Access Compliance Report

Public Rights-of-Way

Intersection ID: 2920	Main Street: FILLIAN_LN	Cross Street: GLENDOCK_CT	Location: SW
ADA ID: 234FDB900724	Ramp Type: PerpDiag	Initial Pass/Fail: Fail	Overall Compliance: No
Severity Score: 37.5			
Codes/Mitigation Info/Possible Solution		Field Measurements/Component Compliance

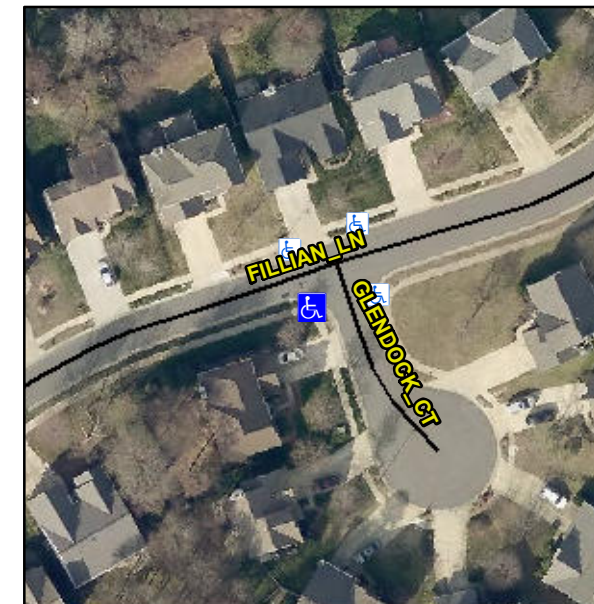
Not Found, R304.5.1, R304.2.2, R304.5.3, R302.7

Compliance	Description	Data	Compliance	Description	Data
N/A	Ramp Length (in)	43.5	No	Ramp Slope (%)	10.4
No	Ramp Width (in)	46.0	No	Ramp XSlope (%)	3.8
N/A	Flare Type LT	N/A	N/A	Flare Type RT	N/A
N/A	Flare Slope LT (%)	N/A	N/A	Flare Slope RT (%)	N/A
N/A	Flare Traversable LT?	N/A	N/A	Flare Traversable RT?	N/A
N/A	Landing Length (in)	N/A	N/A	DWS Provided?	N/A
N/A	Landing Width (in)	N/A	N/A	DWS Contrast?	N/A
N/A	Landing Slope (%)	N/A	N/A	DWS Length (in)	N/A
N/A	Landing X Slope (%)	N/A	N/A	DWS Full Width?	N/A
N/A	Landing Curb? (Y/N)	N/A	N/A	DWS Offset (in)	N/A
N/A	Shared Landing?	N/A			
N/A	Gutter Ponding?	N/A	N/A	Gutter Slope (%)	N/A
N/A	Gutter Lip Ht (in)	N/A	N/A	Gutter X Slope (%)	N/A
N/A	Painted X Walk1?	No	N/A	Painted X Walk2?	No
	X Walk 1 Direction	To E		X Walk 2 Direction	To N
N/A	X Walk 1 Width (in)	N/A	N/A	X Walk 2 Width (in)	N/A
	X Walk 1 Slope (%)	0.1		X Walk 2 Slope (%)	8.2
	X Walk 1 X Slope (%)	3.9		X Walk 2 X Slope (%)	0.3

N/A	Ramp inside XWalk1?	N/A	N/A	Ramp inside XWalk2?	N/A
	Road Slope (%)	1.3	N/A	Clear Space?	N/A
	Road X Slope (%)	4.1	N/A	Clear Space to XWalk (in)	N/A
N/A	Any Obstructions?	N/A	N/A	Storm Grate/Utility Hazard?	N/A
	Obstruction Type			Storm Grate/Utility Type	
		N/A			N/A
		No		Surface Condition? (G/P)	Poor

Remove & Replace Curb Ramp With Two New Directional Ramps or Equivalent.
